**THE CITY OF THE VILLAGE OF DOUGLAS
PLANNING COMMISSION
THURSDAY, JULY 09, 2026 AT 6:00 PM
415 WEST WILEY RD, SUITE 103, DOUGLAS, MI
49406**

To: City of the Village of Douglas Planning Commission
Date: June 22, 2026
From: Sean Homyen, Planning & Zoning Administrator
RE: 86 W. Center St – Special Land Use Request for Hotel/Motel (Section 26.23)

ADDITION & ALTERATIONS
THE DUTCHER HOTEL
1875 HOSPITALITY GROUP, LLC
86 CENTER ST., DOUGLAS, MICHIGAN 49406

SITE PLAN
SCALE: 1" = 10'

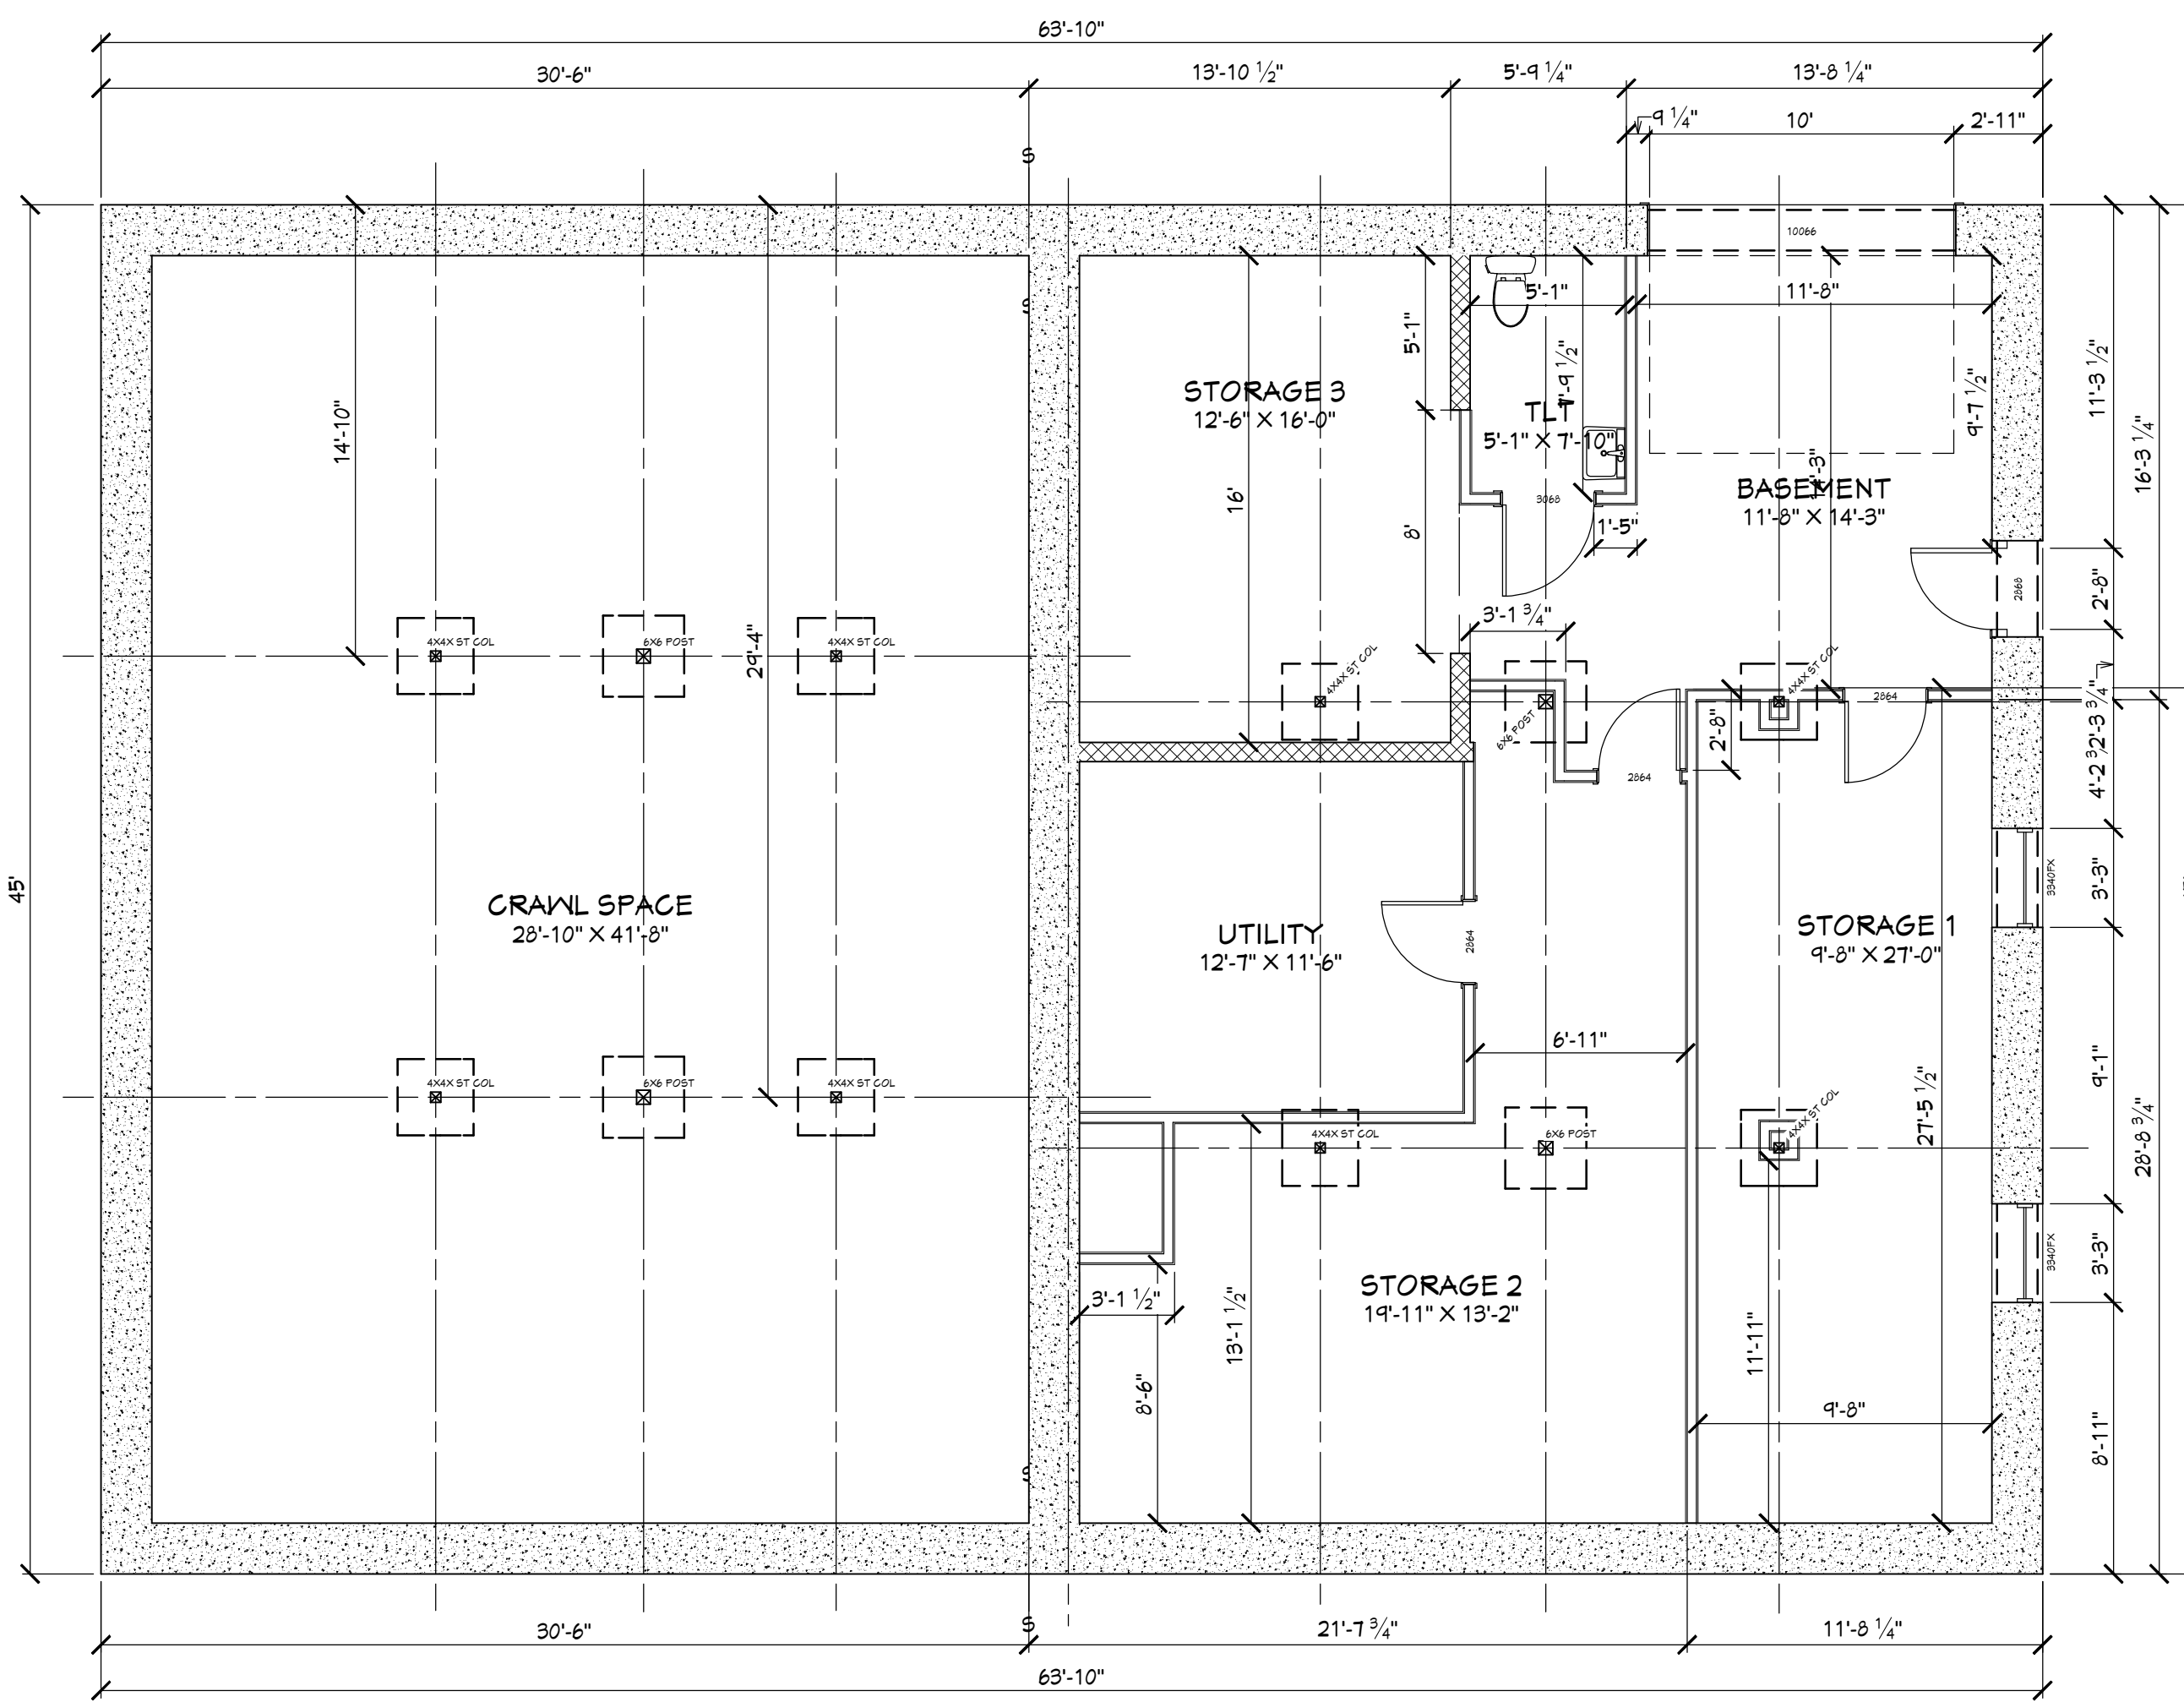
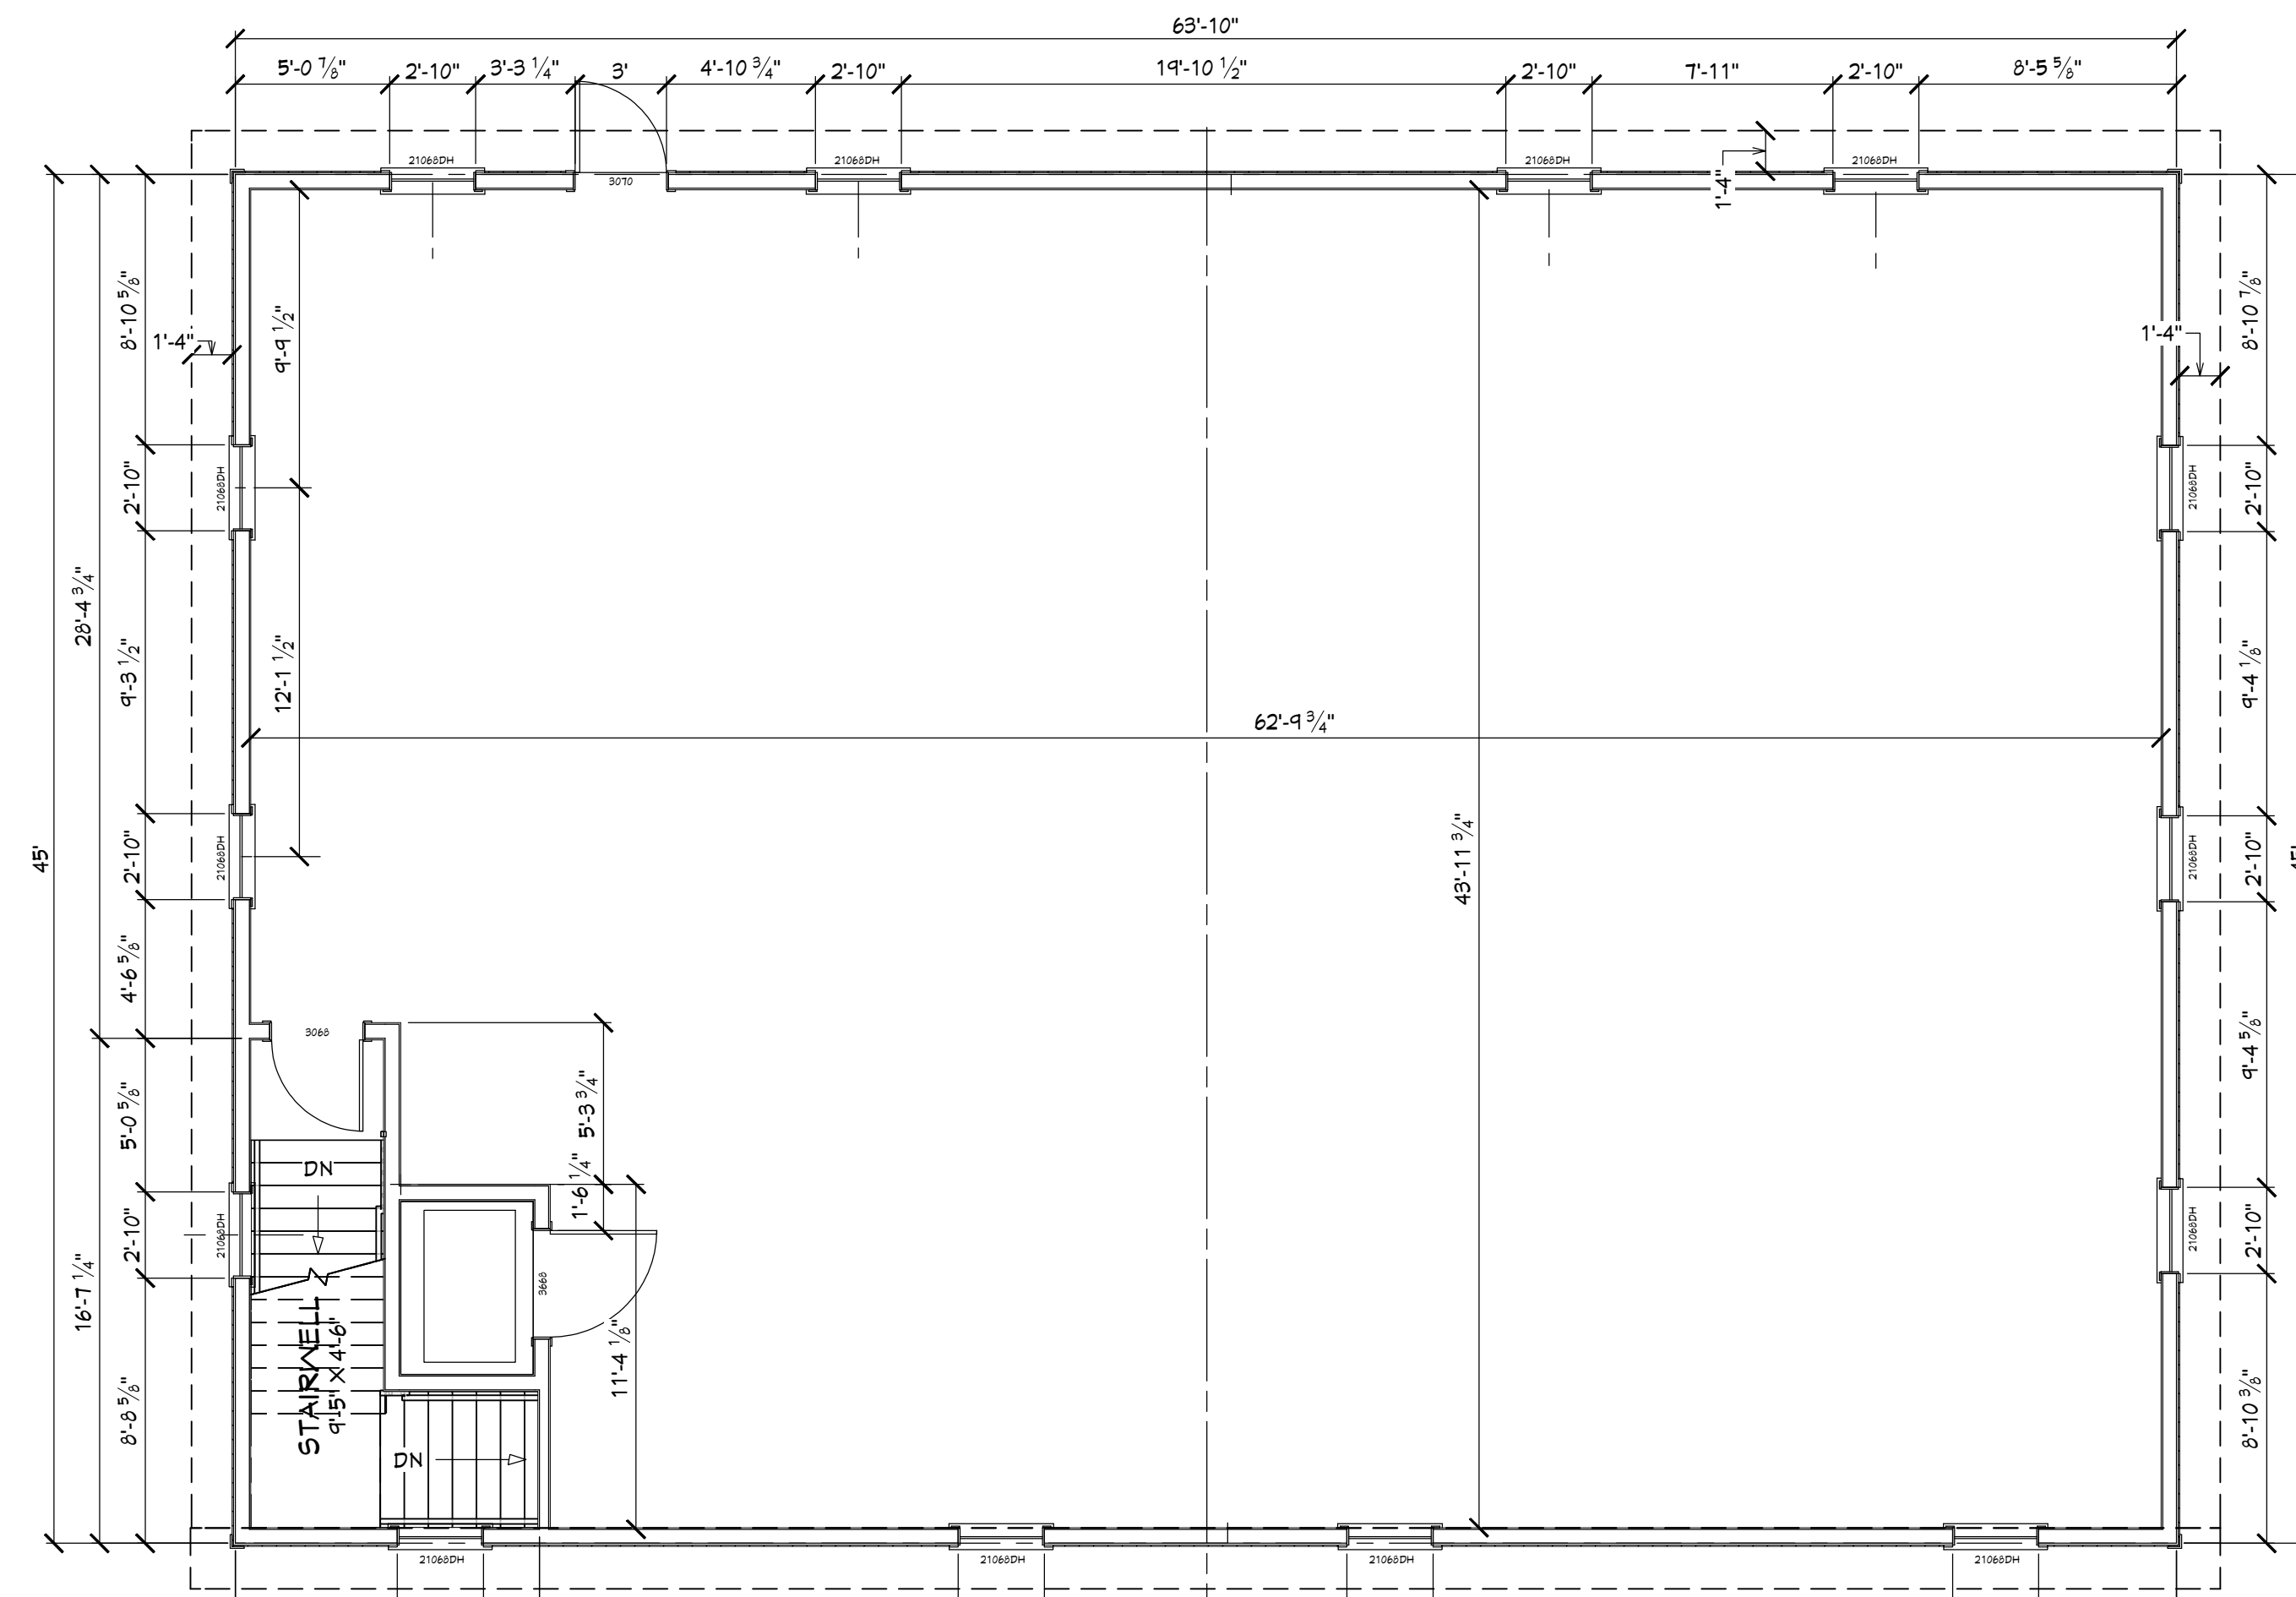
Remarks. Met. A six-foot wooden dumpster enclosure is proposed at the northwest corner of the property.

Remarks. The existing maneuvering lane was approximately 10 feet in width. Based on the proposed modifications, it appears the maneuvering lane has been widened. Although the proposed improvements reduce the existing nonconformity, the applicant shall provide the final maneuvering lane width on the site plan.
